*Diabase Quarry Report of Professional Opinion*

## **H&K Quarry Project**

Springfield Township, Bucks County, PA

Diabase Quarry Report of Professional Opinion

Figure 3:

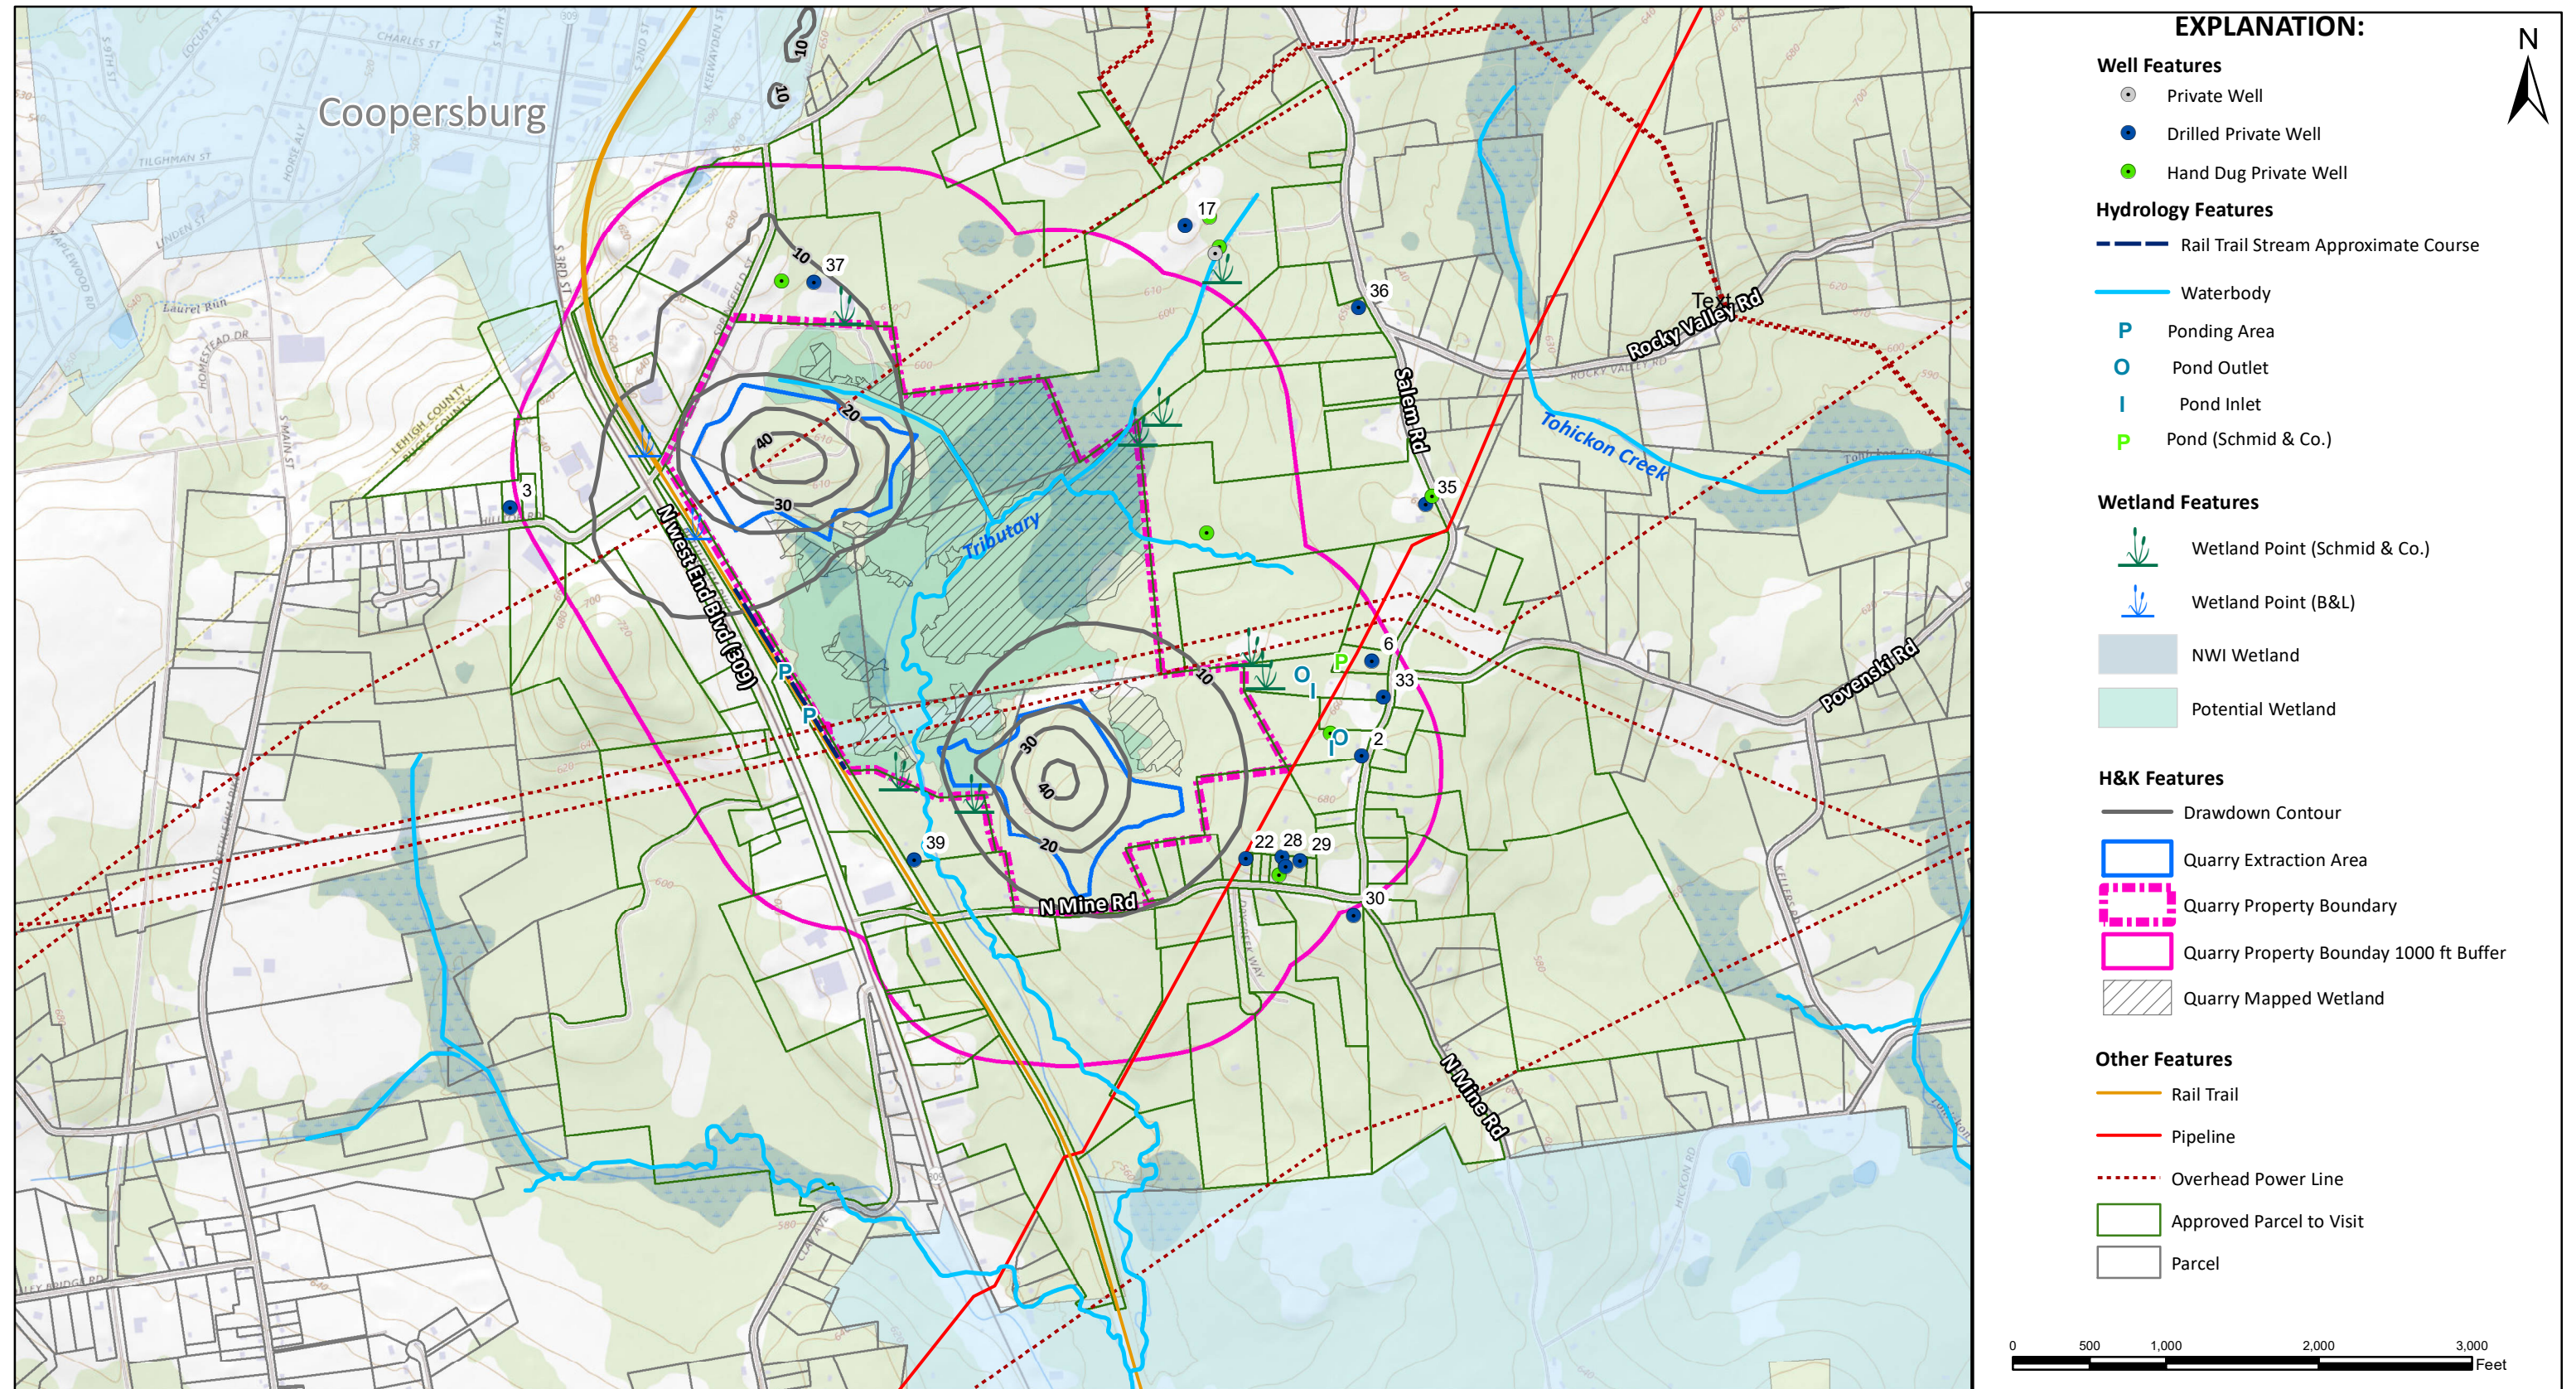
2. Wetlands off-site similarly are not well defined by the very limited NWI wetland mapping. Far more potential wetlands exist off-site compared to NWI mapping (Figure 3). These wetlands and streams with which they interact, or groundwater they recharge, are at risk of indirect impacts from proposed quarrying and dewatering.

The quarry is in the Upper Tohickon Creek watershed (Princeton Hydro, LLC and Boucher & James, Inc., 2005). It is located just west of the headwaters of Hickon Creek, a tributary to Tohickon Creek. Figure 3 shows an abundance of mapped NWI, quarry-identified, and potential wetlands and water bodies (e.g. streams, ponds) on the USGS topographic basemap, including features observed in the site visit.

The quarry NWI, quarry and potential wetlands mapped on Figure 3 (USDA, 2021, MacFaden et. al 2019) and their estimated sizes are compared in the table below.
